Docket Item #8
Development Special Use Permit with Site Plan
#2007-0006
McDonalds Restaurant – 5311 Duke Street

Staff Recommendation: APPROVAL WITH CONDITIONS
Staff Reviewers: Dirk Geratz, AICP and Colleen Rafferty

Figure 1. Proposed site plan

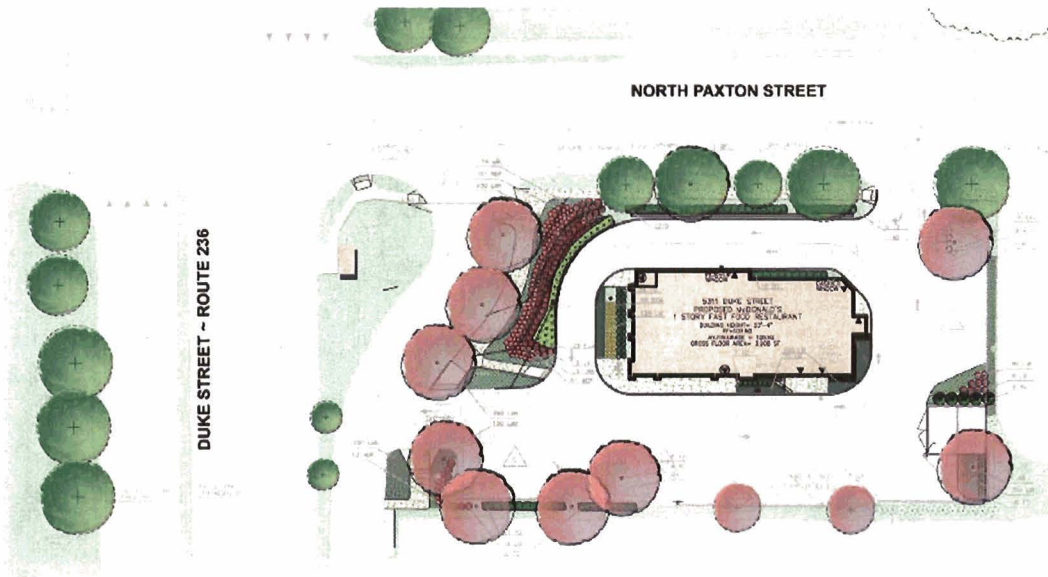
15. Landscape plan shall be generally as depicted in the Preliminary plan with the exception of the conditioned modifications. The following modifications to the landscape plan and supporting drawings are required:

- a. Show landscape plan at a scale of 1" = 10'.
 - b. Clearly depict property line boundary.
 - c. As drawn, it appears that some legend symbols are missing. Correctly display legend on landscape sheet.

- d. Provide City Standard notes on landscape sheet as set forth in the City of Alexandria Landscape Guidelines.
 - e. Provide a screen hedge along the north property line. Modify existing liriopse to create a buffer between screen hedge and parking lot such that overhanging cars do not damage shrubs.

- f. Remove maple trees on the east property line.
 - g. Replace retaining wall along east property line with a permanently constructed wall.
 - h. Remove flowering cherry tree along N. Paxton Street and replace with *Quercus phellos*. (RPCA)
